Upper Trishuli-1 HEP (216MW)

DOOSAN NEPAL BRANCH OFFICE	Address & Contact No. : Four Square Building, Naxal, Kathmandu, Nepal (P.O Box : 1387) + 977 1 692 3014	Project No. H20002	DOCUMENT DISPATCHED BY Courier Service ☐ Messenger ☐ Post-Air Freight ☐ Document System or E-mail ■ By hand ■
DOCUMENT DISTRIBUTION	■ POWER CHINA (Subcontractor) ☐ Doosan's Site Office		
SUBJECT	Review Note RN-0135_Stability Calculations for the Surrounding Rock of Headrace Tunnel

UPPER TRISHULI-1 HEP (216MW)			
Client	**Nepal Water and Energy Development Company Private Limited**		
Owner's Engineer	**Tractebel Engineering GmbH / Jade Consult**		
REVIEW NOTE			
Contractor	**Doosan Enerbility**		
Title of the Document	Stability Calculations for the Surrounding Rock of Headrace Tunnel		
Document No.	UT1-C-150-CVL-DC-54001	Revision	0A
Date of Documents	31.05.2022	Received Date	31.05.2022
Transmittal Form No.	UT1-HEP-DHI-D-0249		
Previous Review Date/Status	N/A	Prev. Review Note No.	N/A
Review Note No.	**RN-0135**	**Present Review Date**	**06.06.2022**
		Present Review Status	**AN**
A: Approved AN: Approved as Noted RR: Returned for Resubmission FI: For Information, only

Figure 1-1 Typical section of headrace tunnel (rock class I)

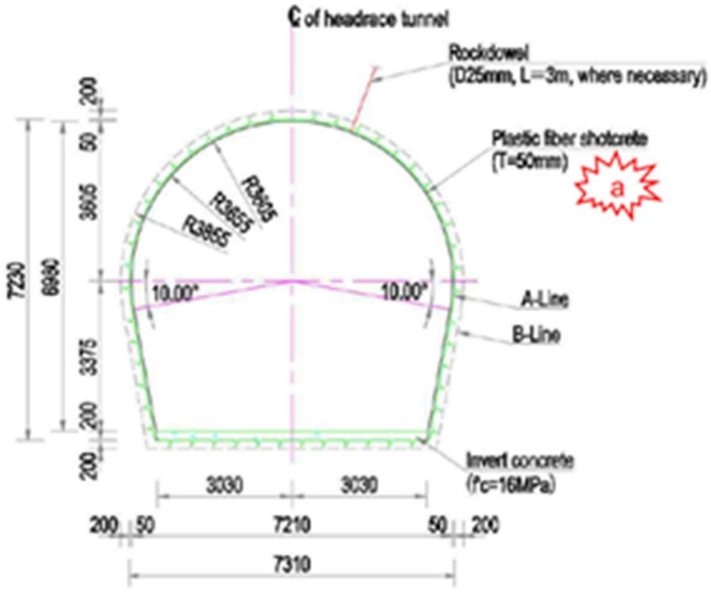
(a) There is no reason to apply 50 mm shotcrete in Class I rock. Why to replace solid rock of high strength with comparatively low strength shotcrete? This is independent whether the liner will be perforated, or not. Omit.

Figure 1-5 Typical section of headrace tunnel (rock class IV, buried depth between 240m and 458m)

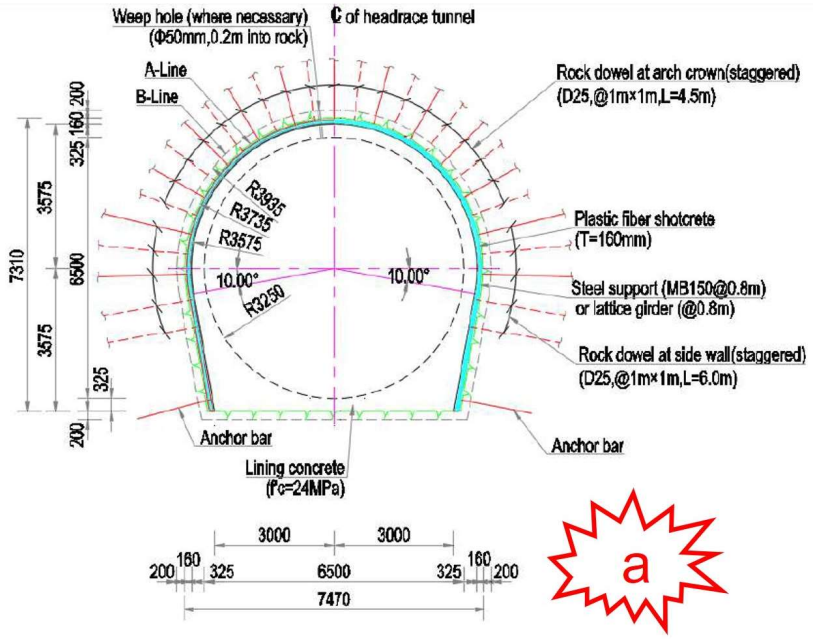
(a) The reviewer questions the geometry given in the drawings. The same excavation size is given for the tunnel without and with steel rib support. The steel rib shall not be embedded in the reinforced concrete liner. Revise.

Figure 1-6 Typical section of headrace tunnel (rock class V)

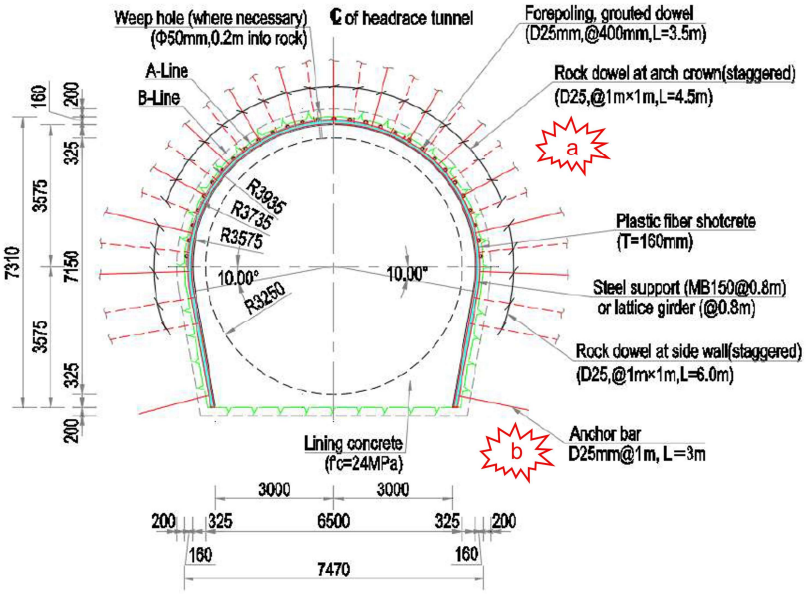
(a) Indicate ground improvement measurements as indicated in the text and specified further below. Provide several improvement suggestions (grouting, canopy tubes etc.) and specify in a table.
(b) Provide provision for steel invert strut.

Figure 6.2-4 Bearing capacity of shotcrete (Rock Class II, 608m)

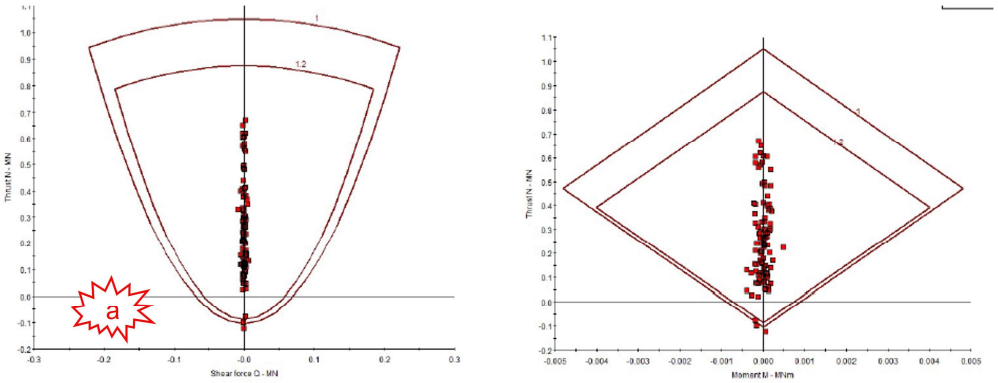
(a) The results show that the shotcrete liner does not satisfy the design requirements. This should be stated.

Figure 6.3.2-1 Surrounding rock plastic zone (Rock Class III) (buried depth 608m)

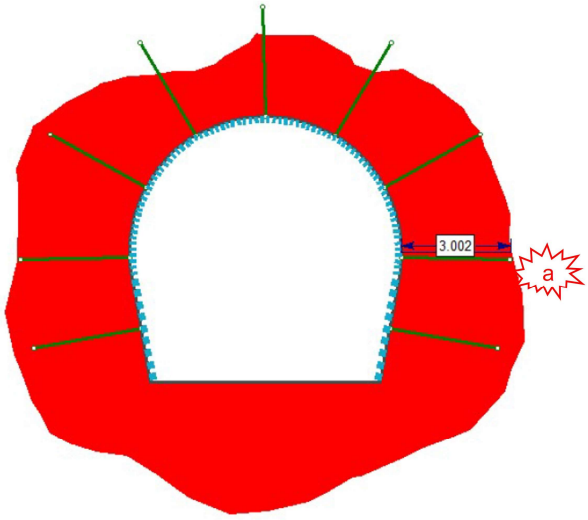
(a) The length of dowels needs evidently be adjusted. Revise respective drawing.

Figure 6.4.6-5 Bearing capacity of steel support (Rock Class IV, 608m)

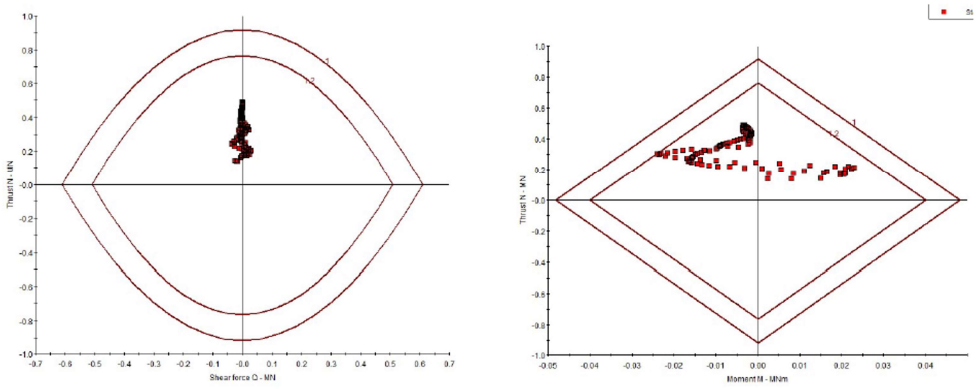
(a) What is the conclusion from this statement? Ground improvement, heavier support? Specify.
